11th IWG GTR 13

Status of TF 1

Status on September 28th, 2021

1. TPRD Direction – China proposal

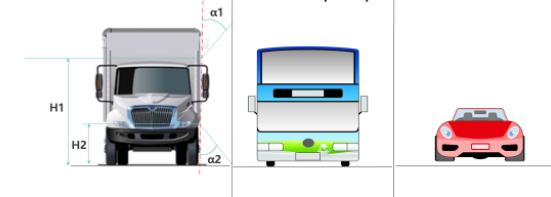
- Considering the safety of traffic participants, there are two plans :
Plan A: The gas discharge is higher than H1, and upwards within $\alpha 1$ of vertical surface ;
Plan B: The gas discharge is lower than H2, and the downwards within $\alpha 2$ of vertical surface.
1. not design-restrictive.
 2. towards the possible static-electric points for FCVs.
 3. the two angles' reason, and any test to verify? for LDV, towards at an upper angle, or for HDV, towards at a lower angle is dangerous to other road users.

Considering the safety of traffic participants, there are two plans:

- Plan A: The gas discharge is higher than H1, and upwards within $\alpha 1$ of vertical surface;
Plan B: The gas discharge is lower than H2, and the downwards within $\alpha 2$ of vertical surface.

TPRD Direction – OICA proposal

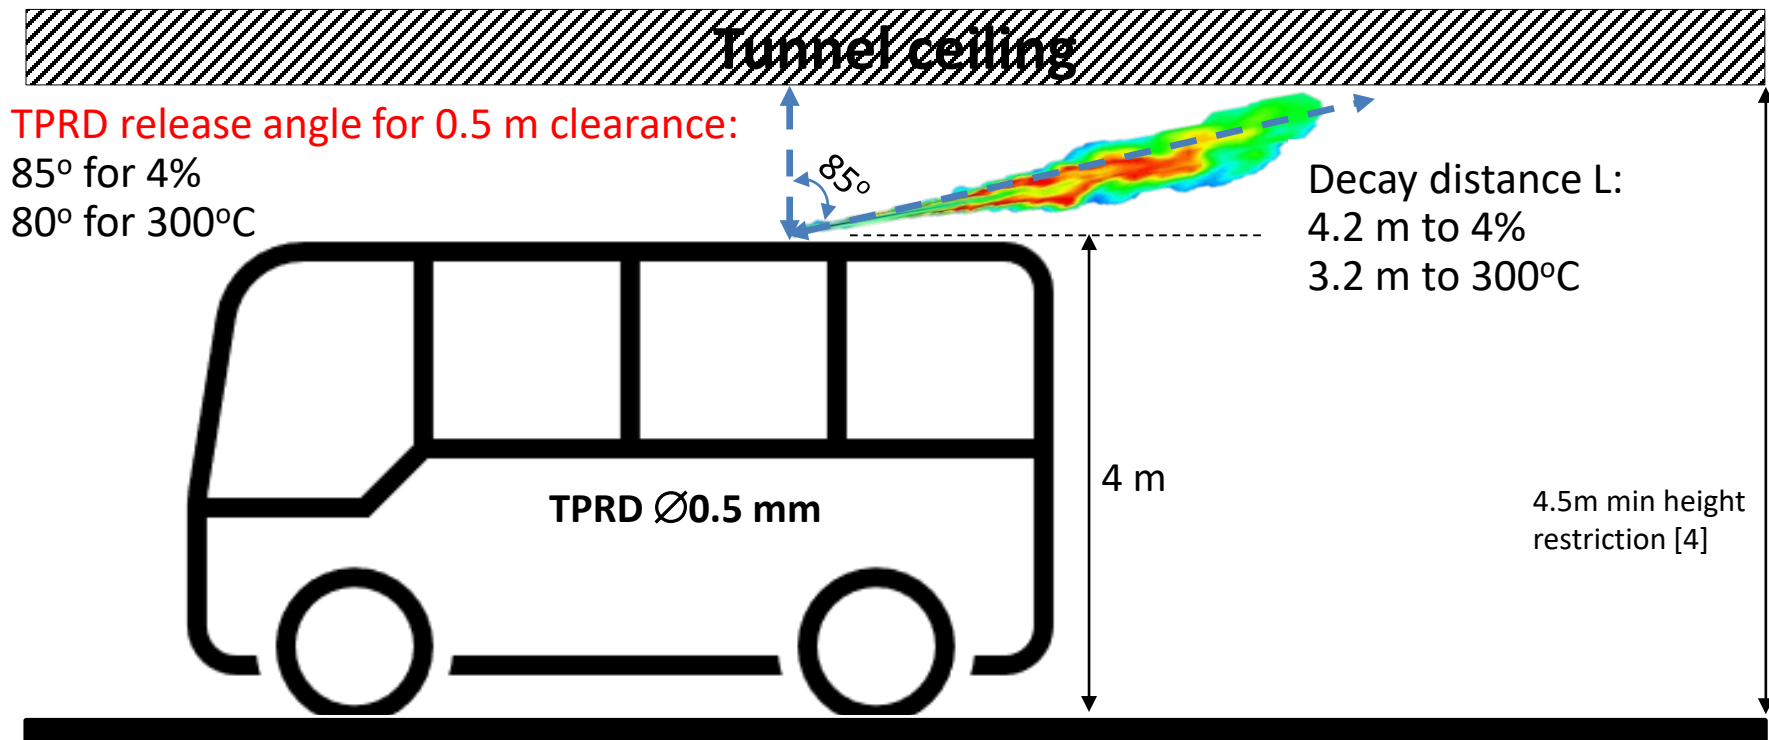
Release from bus/truck in tunnel

Example of angle to satisfy hazard criteria

- For upward release from the bus or truck in a tunnel or maintenance shop the clearance between the TPRD $\varnothing 0.5\text{mm}$ and the ceiling should be sufficient to allow decay of the jet below 4% and 300°C, same as for the car in underground car parking
- Jet attachment is not considered and should be accounted

TPRD – China proposal

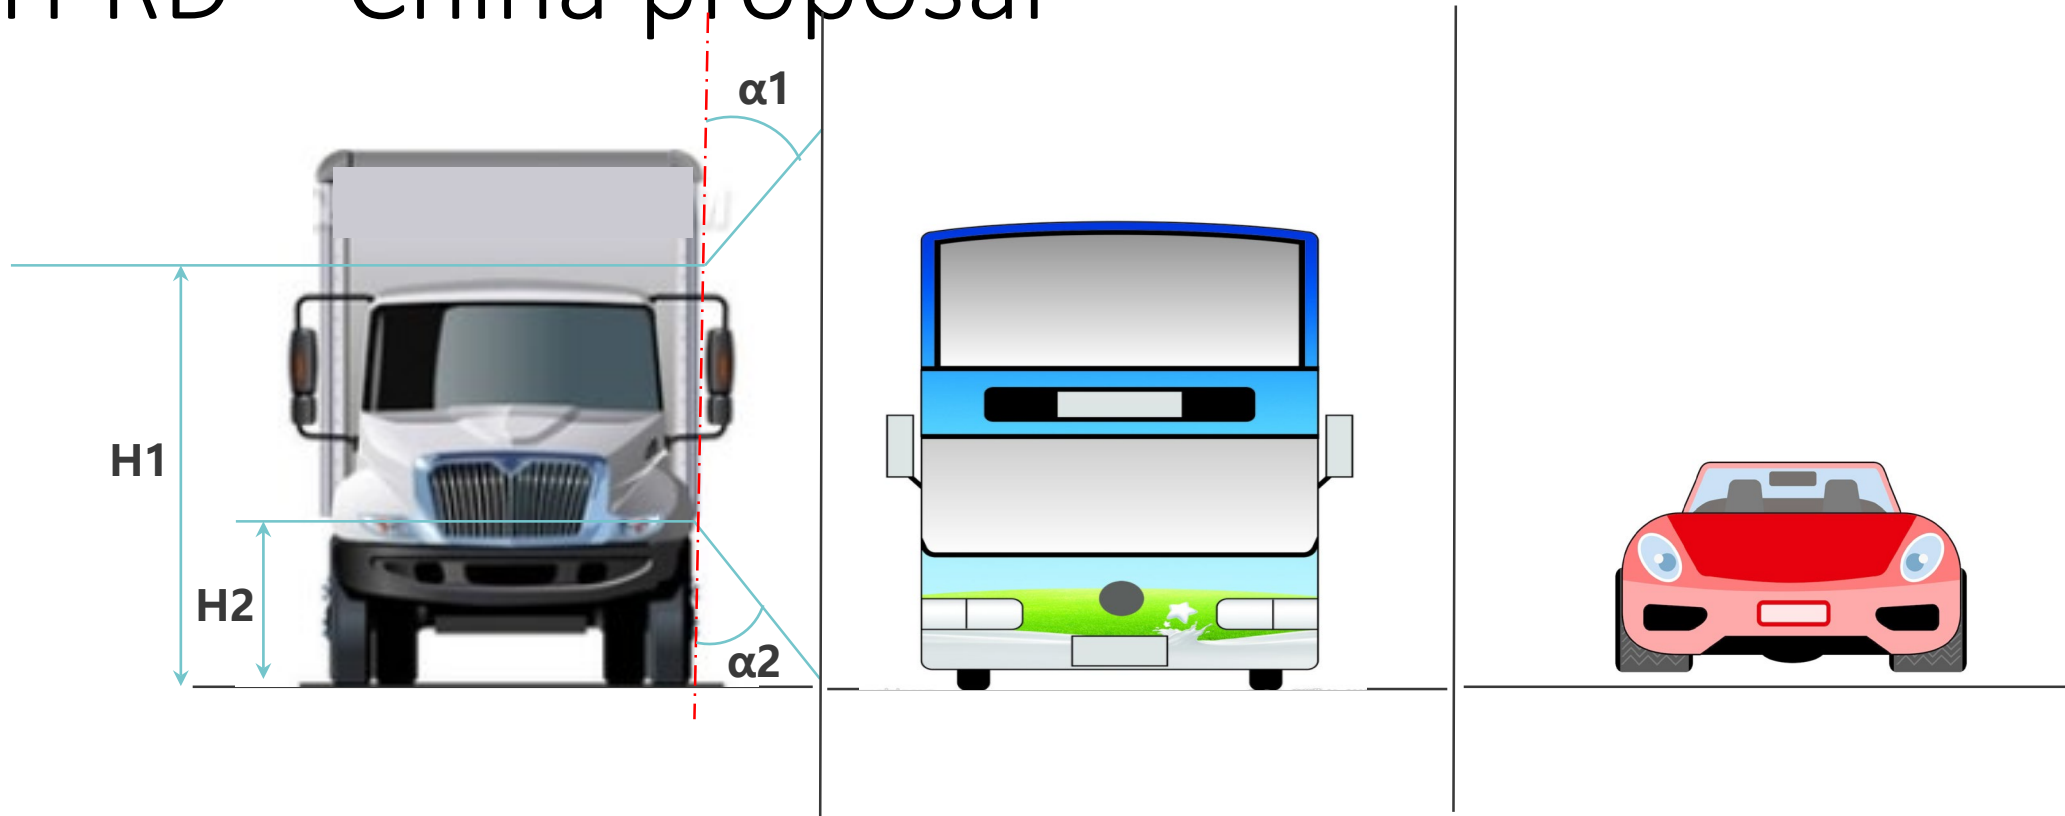
Considering the safety of traffic participants, there are two plans:

Plan A: The gas discharge is higher than H1, and upwards within $\alpha1$ of vertical surface;

Plan B: The gas discharge is lower than H2, and downwards within $\alpha2$ of vertical surface.
